Substantive response of the Local Highway Authority to a planning consultation received under The Development Management Order.

Planning Application Number: 23/00573/FUL

Application Address: Land To The West Of Normandy Way Hinckley Leicestershire

Re-consultation. Full planning application for 153 dwellings with a vehicular access from the factory access road and existing roundabout on the A47, drainage, landscaping, public open space, ground remodelling and supporting infrastructure and utilities.

Capricorn Transport Planning drawing number: C21021-DR101 Development Access Arrangements: Option 1, Revision A

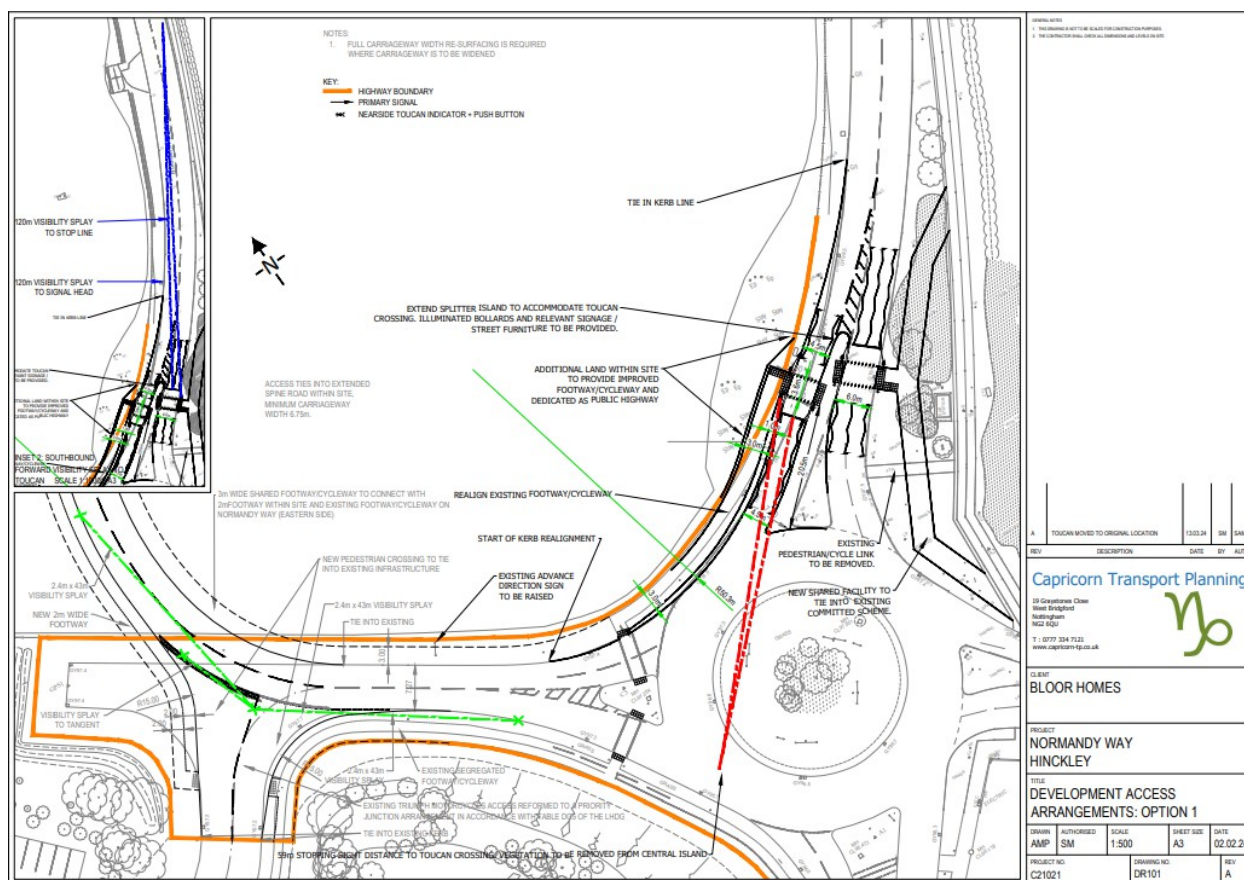
- For the signal crossing tactile paving the stems should be on the right hand side of the crossing and not on the left (see Figure 3A of Guidance on the use of tactile paving surfaces). The paving should also be two slabs deep and not three. **Accepted. Drawing to be amended.**

- Previous highway comments raised the issue of exit width leading towards the new crossing being less than the 7m required by the DMRB CD116. This is because of the requirement to include a toucan crossing. The splitter island is very wide and could allow a broken-down vehicle to mount the kerb and enable vehicles to pass, if a splayed kerb were provided for the splitter island. **Accepted. Note will be added to drawing to specify kerbing of height sufficient to prevent kerb mounting, in conjunction with suitable road markings (see below).**

- Visibility splays for the proposed access should be based on measured 85th percentile speeds and not the posted speed limit. **Please see CTP Response Note dated 26/03/24, Page 7. This is a proposed new road and existing speeds cannot be measured. Therefore, please confirm that the 2.4m x 43m visibility splays are acceptable.**

- As the access is located on the outside of a horizontal bend, an additional visibility area ought to be shown to a point tangential to the nearer edge of the main road carriageway, as per DMRB CD123 Figure 3.9. **Accepted. Drawing to be amended.**

- Road markings on the roundabout should be shown, demonstrating how the layout will ensure vehicles do not collide with the southwest corner of the proposed wider splitter island. **Accepted. Drawing to be amended.**

- A Stopping Sight Distance (SSD) of 59m is shown on the drawing for the proposed traffic signals, however speed readings would be required to determine whether the SSDs are in accordance with the requirements of DMRB CD109 Table 2.10. **Please see CTP Response Note dated 26/03/24, Page 8. Measured 85th percentile speeds documented in the TA support proposed 59m SSD. Therefore, please confirm that these are acceptable.**

- The existing cycling facilities on the eastern side of Normandy Way are segregated. In accordance with the requirements of LTN1/20 segregated footway/cycleway facilities should be provided between the new Toucan crossing and the site access. **A 3.0m wide shared use facility is shown adjacent to the carriageway, which is consistent with the accepted cross-section along the remainder of the Spine Road. Whilst it would be possible to provide the additional width for a segregated facility using land within the site, this would provide little benefit if only on the short section between the Toucan and the Roston Drive crossing points. Furthermore, we note that Active Travel England (ATE) has accepted the proposals as they stand. Further discussion required.**

- For the traffic signals, the signal head is pointing in the wrong direction for the west side crossing, a secondary signal head is required for the east side crossing, some push buttons are shown without poles. **Accepted. Drawing to be amended.**

Junction 2: A47 Normandy Way / Roston Drive (proposed with pedestrian crossing)

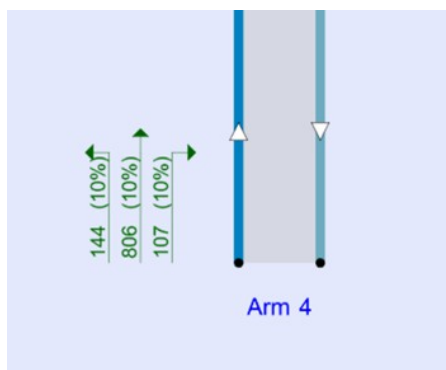
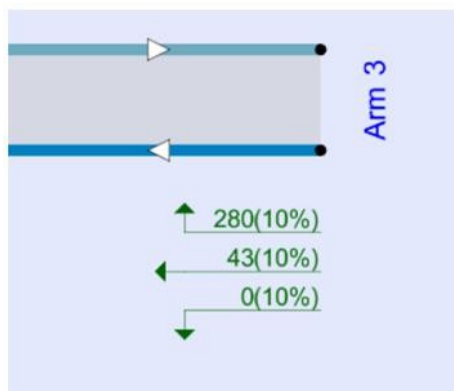
The LHA have a concern about this model relating to the proposed narrowing of the carriageway on Arm 1 (A47 North) which will result in the removal of the existing 2-lane exit. This means that traffic on Arm 4 (A47 South) will no longer be able to use both lanes to go ahead to A47 North (Arm 1).

The traffic flows on A47 South are imbalanced, in the extract from the model shown below for example, 950 pcus will use lane 1 to go left/ahead and only 107 pcus will use lane 2 as it will no longer be possible to use both lanes to go ahead:

There are also imbalances in flows on Arm 3 where most traffic is turning right:

The ARCADY model assumes that approach lane flows are balanced, and corrections should be made to the model to account for unequal lane usage (e.g. as per the advice in the Barbara Chard “Arcady Heath Warning” which can be found at http://231618.vps-10.com/Home/docs/tec_arcadyHealthWarning.pdf). Alternatively, the use of “Lane Simulation” mode in the model should give more accurate results.

The model has been adjusted to reflect the unequal lane usage on the A47 South (Arm 4) as noted above, using the Barbara Chard methodology (intercept correction). This is documented in our Response Note dated 26/03/24 and the model files for this scenario were also forwarded to LCC for review. Please confirm that this model has been reviewed and is acceptable.

Although no intercept correction has been applied in the case of Roston Drive East (Arm 3), doing so is unlikely to make a significant difference to the conclusion reached due to lower traffic demands and short flare. However, the model will be re-run with the appropriate correction applied for completeness.
